FirstEnergy Nuclear Operating Company

L-15-337

Beaver Valley Power Station, Unit No. 2
Docket No. 50-412, License No. NPF-73
Completion of Required Action by NRC Order EA-12-049, Order Modifying Licenses with Regard to Requirements for Mitigation Strategies for Beyond-Design-Basis External Events (TAC No. MF0842) and NRC Order EA-12-051, Reliable Spent Fuel Pool Instrumentation (TAC No. MF0800)

By letter dated November 19, 2013, the Nuclear Regulatory Commission (NRC) issued an interim staff evaluation (ISE) and request for additional information (RAI) regarding the Beaver Valley Power Station, Units 1 and 2 (BVPS-1, BVPS-2) overall integrated plan for implementation of NRC Order EA-12-051, Reliable Spent Fuel Pool Instrumentation. Subsequently, by letter dated March 26, 2014, the NRC staff transitioned to an audit-based review process that allowed the use of the licensee's ePortal to provide responses to the RAIs to support the staff's review process. FirstEnergy Nuclear Operating Company (FENOC) utilized the ePortal to provide the majority of RAI responses for BVPS-2. The compliance date for BVPS-2 was October 24, 2015. The ISE RAIs are provided below as they pertain to BVPS-2

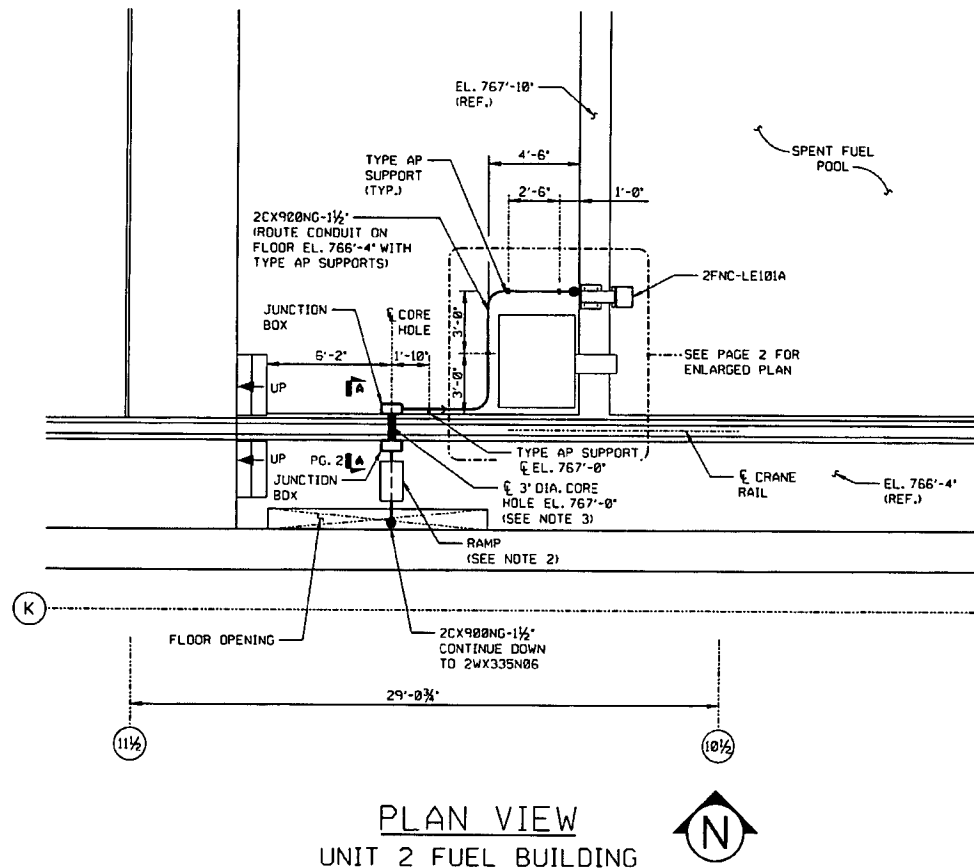
Please provide a clearly labeled sketch or marked-up plant drawing of the plan view of the SFP [spent fuel pool] area, depicting the SFP inside dimensions, the planned locations/placement of the primary and back-up SFP level sensor, and the proposed routing of the cables that will extend from these sensors toward the location of the read-out/display device.

The response to this RAI was provided by FENOC letter dated February 27, 2014. Subsequently, by FENOC letter dated February 26, 2015, the design for BVPS-2 progressed from conceptual design to final design. As a result, some of the locations of the instrumentation and conduit routing were changed. Updated sketches are provided below, depicting general configuration. Previous versions of these sketches were made available to the NRC staff for review.
